Rapiscan Systems	Secure 1000 Radiation Emission Measurement	FORM R-0646-1 (Single Pose)

Re: Rapiscan AIT System Radiation Survey Reporting

R-0646-1 Addendum
(Documentation Errors)

Product Name	Secure 1000SP (Single Pose)
Serial Number	S51009007
Radiation Emission Measurement	Radiation Survey Dated: 06/18/2010
RSO Initials	[redacted]

1. In Beam Dose Measurement: Survey Table. 1

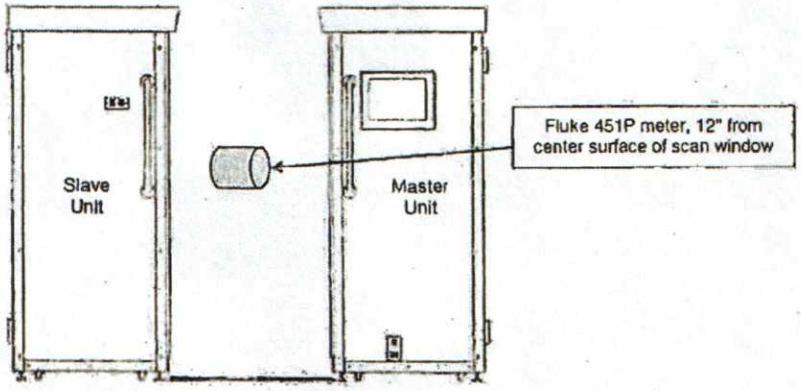
3. TABLE 1: Incorrect presentation of data in Column 3 for Measured Exposure. Indicated values are 22uR and 29uR. Corrected values are 2.2uR and 2.9uR. The values were corrected by technician when calculating Effective Dose.

2. Radiation Leakage Measurement: Survey Table. 2

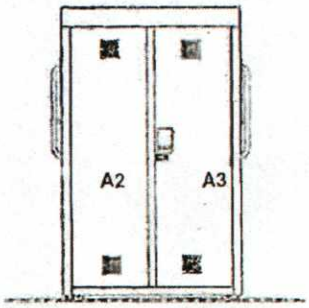
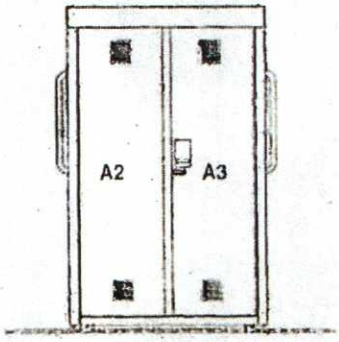
4. TABLES 2 and 3: Incorrect presentation of data in Column 6 for Dose Equivalent. Indicated values are .18 uRem. The correct value should be 1.8 uRem.
